June 21, 2017

Reference No.: 141-24579

Re: Addendum to Traffic Impact Study:
Proposed 'Windgate Village' Mixed Use Development (WSP Canada Inc, March 2015)

Figure 1: Original Concept Plan

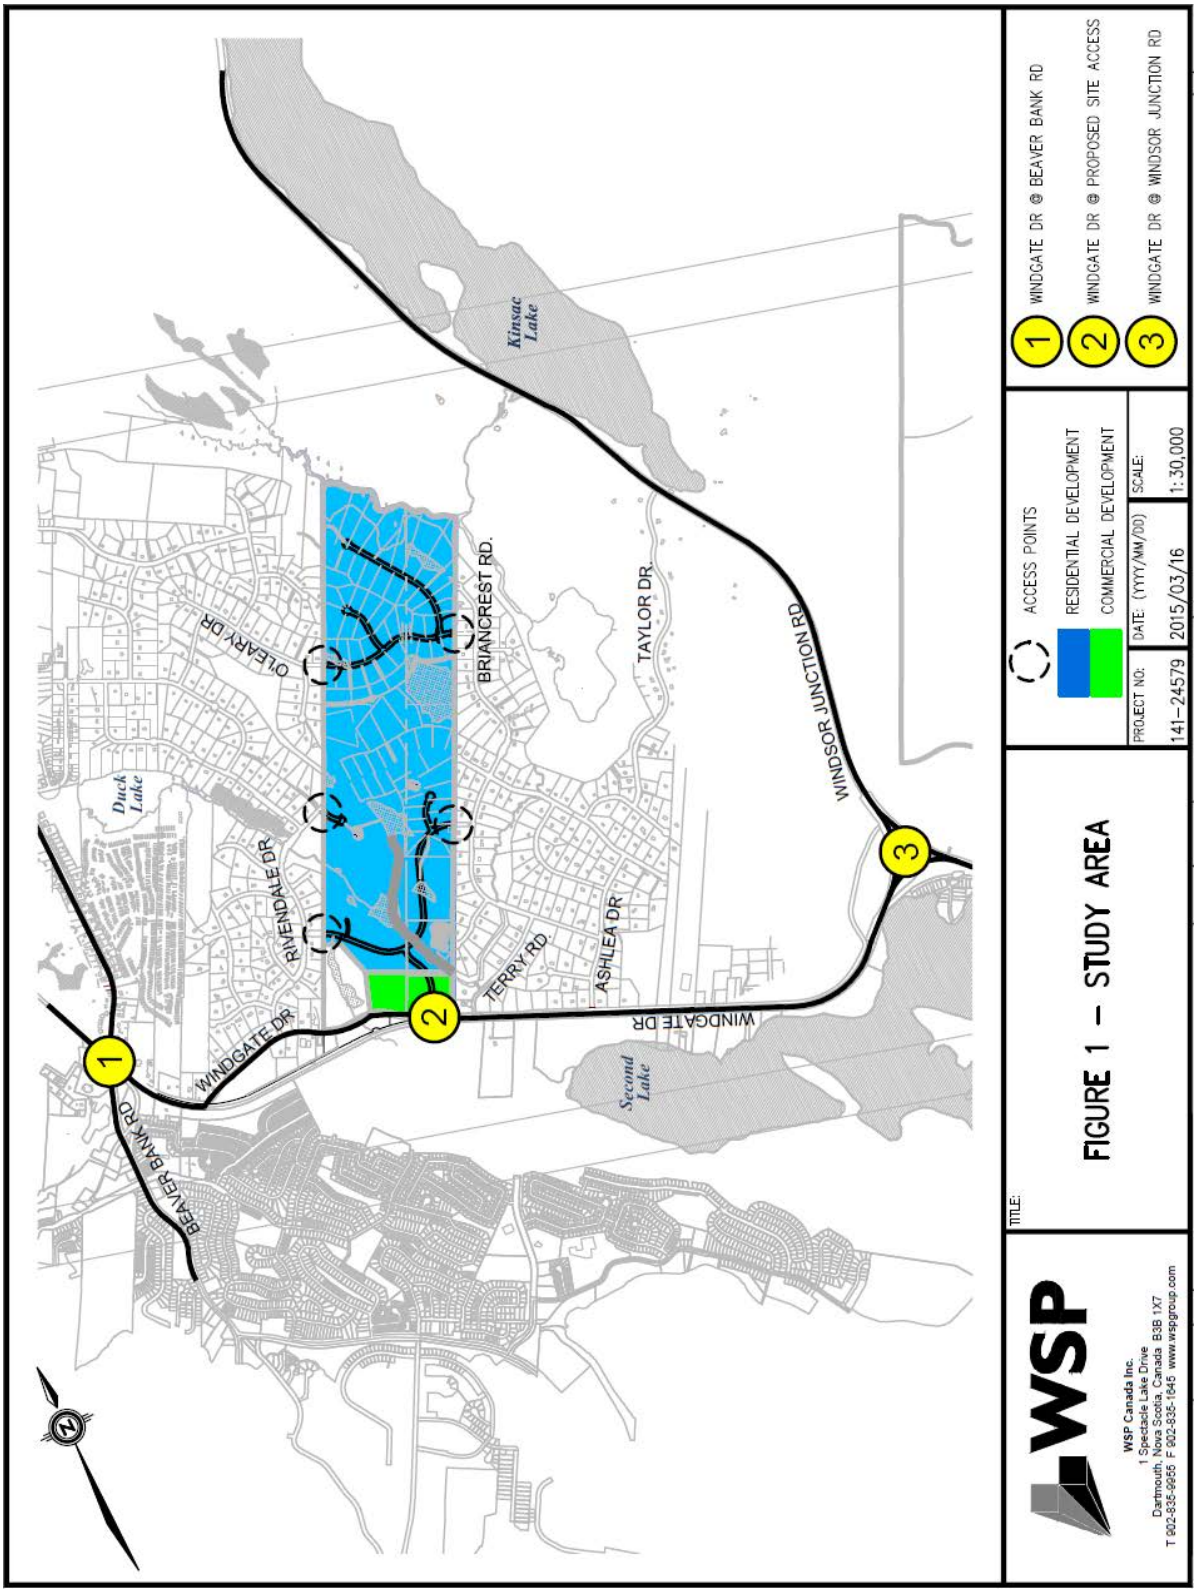
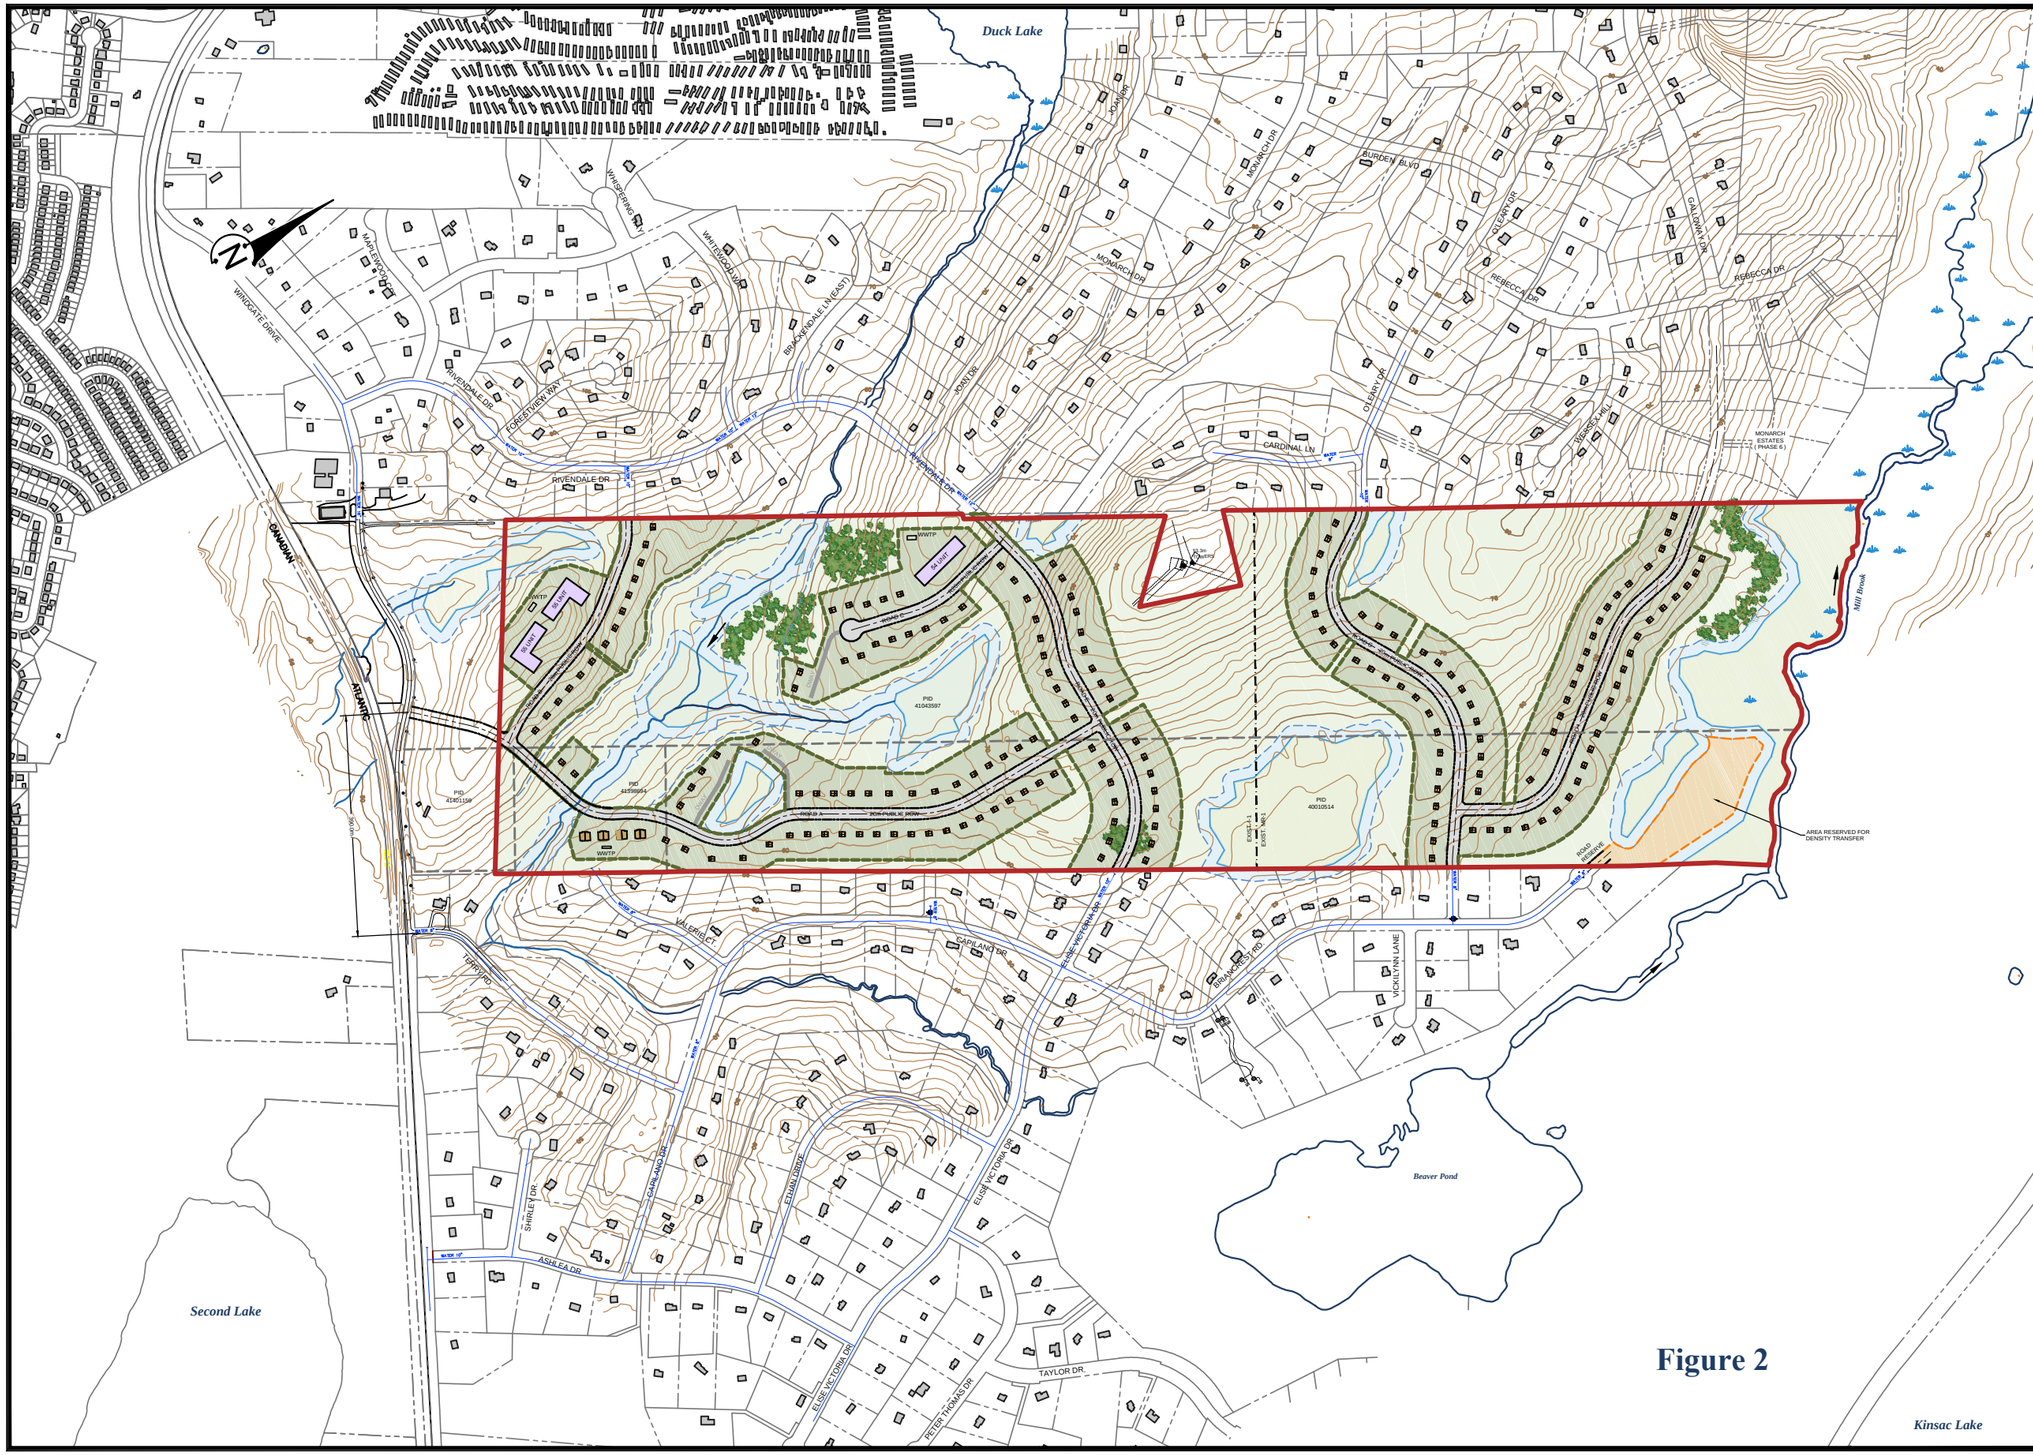
- **Original Concept (Figure 1):** The original development concept included a mix of residential and commercial land uses. The south end of the parcel – located adjacent to Windgate Drive – included commercial developments, a mix of multi-unit and single family residential units, and a sports field / community park. The north end of the parcel, accessed via existing residential streets, comprised single family residential units only.

- **Revised Concept (Figure 2):** The revised development concept includes residential developments only; the commercial component has been eliminated. The south end of the parcel includes a mix of single family residential units and multi-unit apartment buildings. The north end of the parcel comprises single family residential units only.

Table 3: Road Network – Original and Revised Development Concepts

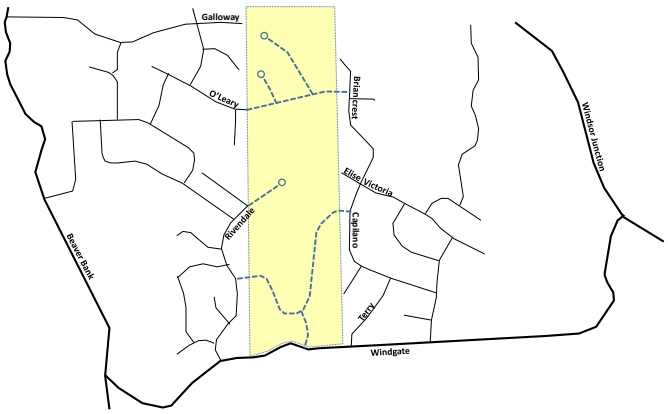
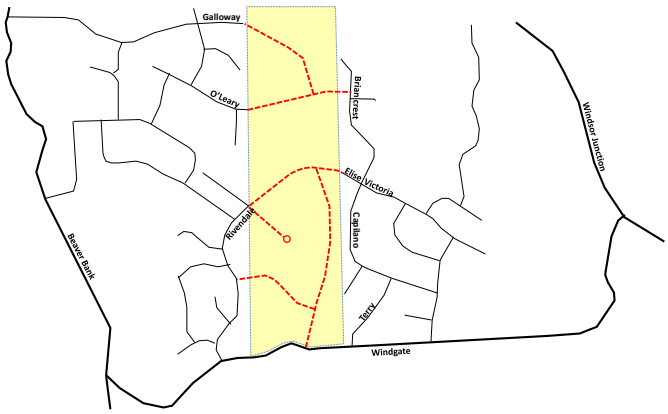
The road network configurations for both concepts are illustrated in Table 2. Overall, the revised concept road network is similar functionally; however, it does include some notable modifications:

- The primary east-west road through the south end of the development, which in the original concept was a new road running between Rivendale Drive and Capilano Drive, is now a direct connection between the current limits of Rivendale Drive and Elise Victoria Drive.
- The access road to Windgate Drive, which is proposed just north of the previous location, is a more prominent north-south road through the south end of the development.
- The revised road network at the north end of the development includes a direct connection to Galloway Drive.

Since the road network in the revised development concept is similar functionally to that proposed in the original concept, it is expected that changes to traffic assignment relative to the original TIS will be negligible.

Figure 3: Sightlines at Proposed Site Access Location approximately 390m West of Terry Road

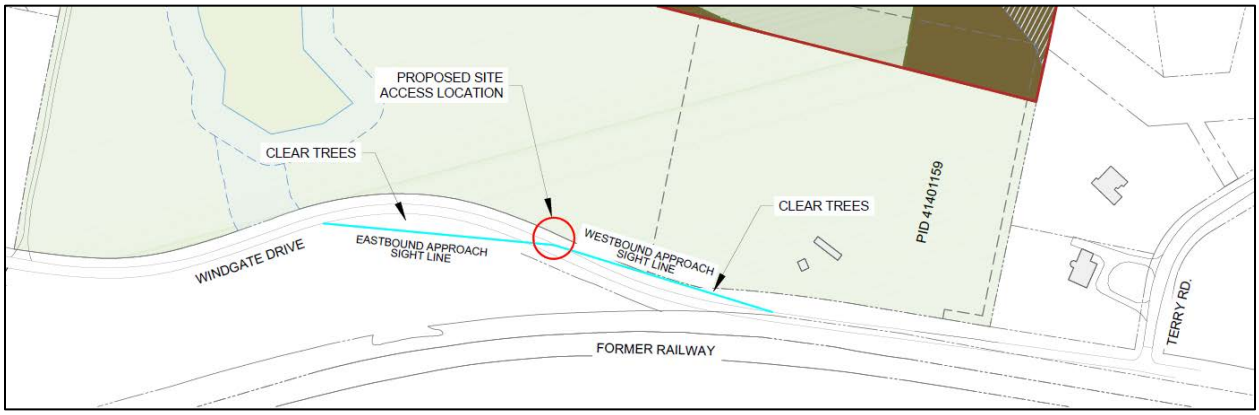
A site access location intersecting Windgate Drive approximately 390m west of Terry Road is expected to provide adequate SSD with tree clearing inside the horizontal curves for the Windgate Drive approaches. The sight lines for 150m on both approaches and locations where tree clearing is required are summarized in Figure 3. Available SSD at this location should be re-evaluated once trees have been cleared to confirm the intersection location.

5. The location of the proposed access road to the south end of the development via Windgate Drive was further investigated in order to determine a location that meets stopping sight distance (SSD) requirements. An access location approximately 390m west of Terry Road is proposed provided that trees are cleared to improve sight lines on both the eastbound and westbound approaches.
